FT4869R1 - Surge tank cover Chafing on Components

MQR 7621-1762 : Service Solution (Shim)

Surge tank cover Chafing Components – Interferences & Solutions

Revision 01

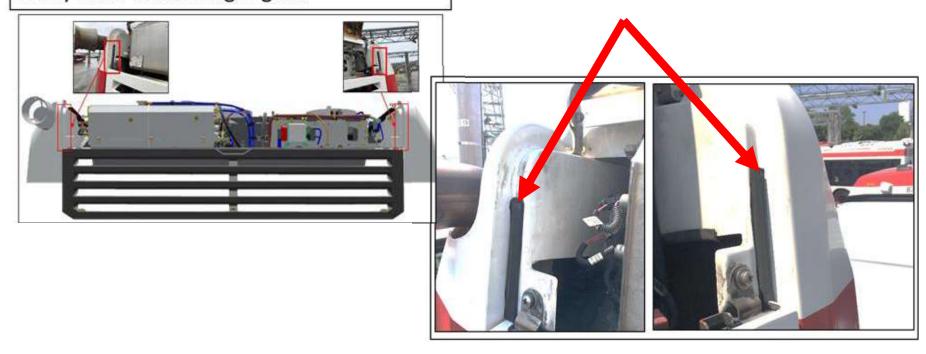
- 6) Rework Instructions: (Sigh Glass contact ONLY)
- a) Clean area with isopropyl alcohol
- b) Apply double sided tape item 4 (680796) on neoprene item 6 (N32920)
- c) Install as shown on pictures below

Closed cell ¼" thick foam tape installed to shim canopy outward Away from coolant sight glass

New proposed installation

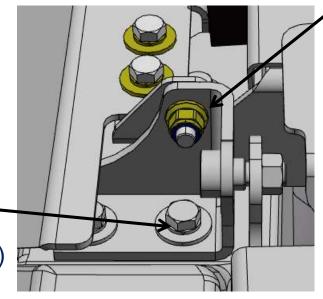
- 7) Installation Instructions (Shim):
- a) Retain indicated hardware

Discard original Lock Washer N28220
Retain original flat washer N28219

Add new Washer N34792 2x 2,28MM thk (Shim)

Reinstall original screw N31413
Retain original flat washer N29011
install new Lock Nut N43233
Torque 27.2 ± 2 Nm
Add Torque seal

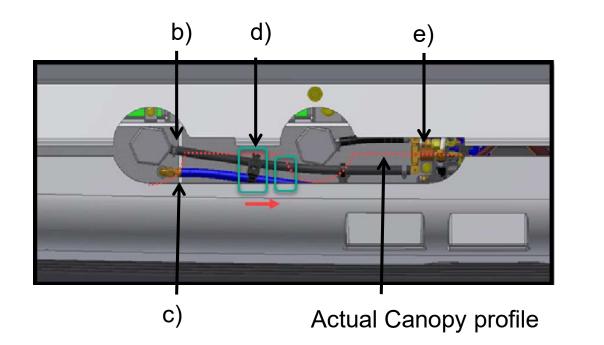
Gain of 4mm to avoid contact of the following components;

- b) Rubber Tube Chafing on Canopy
- c) Fitting and Rubber Tube Chafing on Canopy
- d) Tyton Chafing on Canopy (relocate if required, as shown)
- e) P-Clamp Chafing on Canopy
